Product Change Notification / CENO-11FRYW234

CCB 5131 Final Notice: Qualification of C194 as an additional lead frame material for selected DSPIC33EPxxxxx, PIC24EP12xxxx, PIC24EP25xxxx, PIC24EP32xxx and PIC24EP64xxx device families available in 48L UQFN (6x6x0.5mm) package.

CCB 5131
Pre and Post Change Summary
PCN #: CENO-11FRYW234

Pre Change

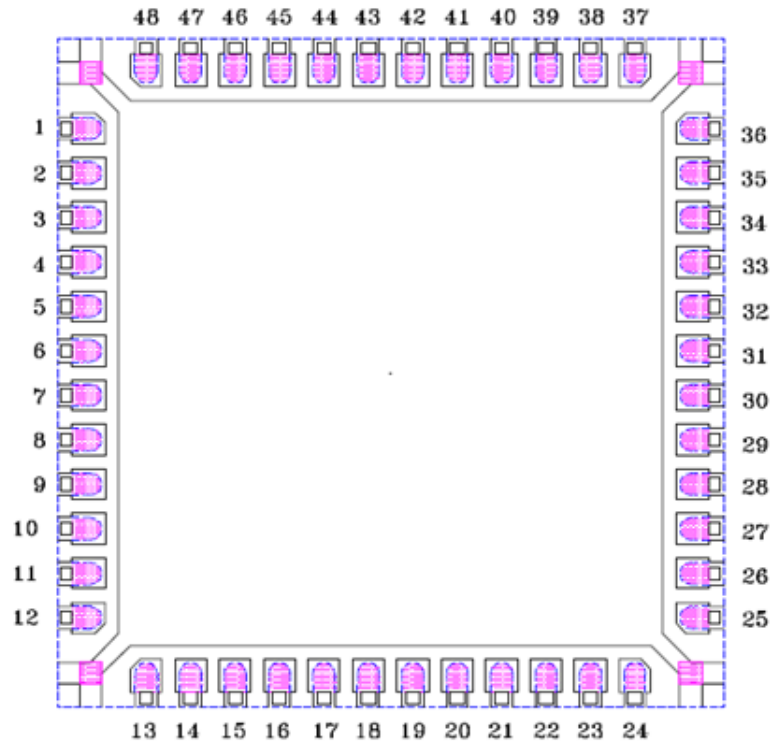
Lead frame Material

EFTEC64T

Post Change

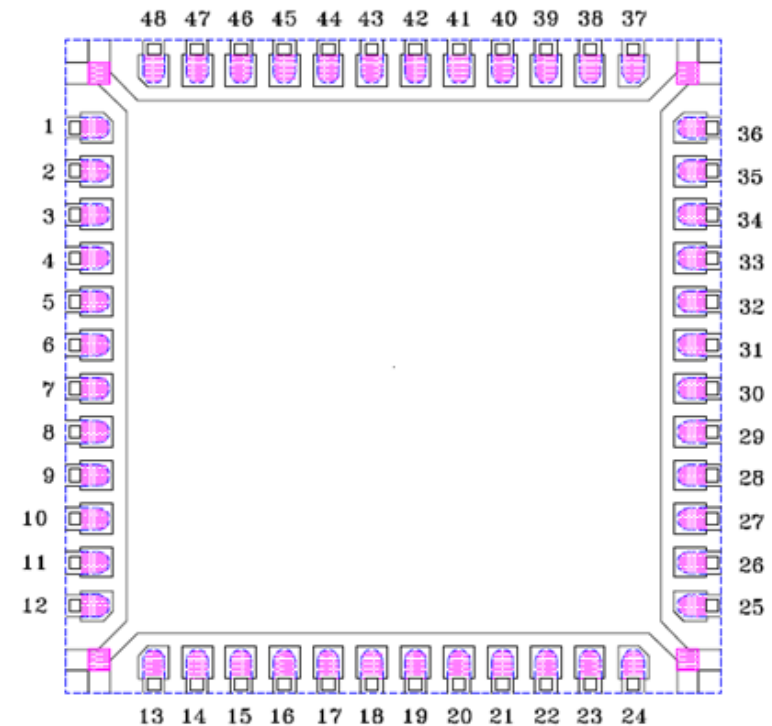
Lead frame Material

C194
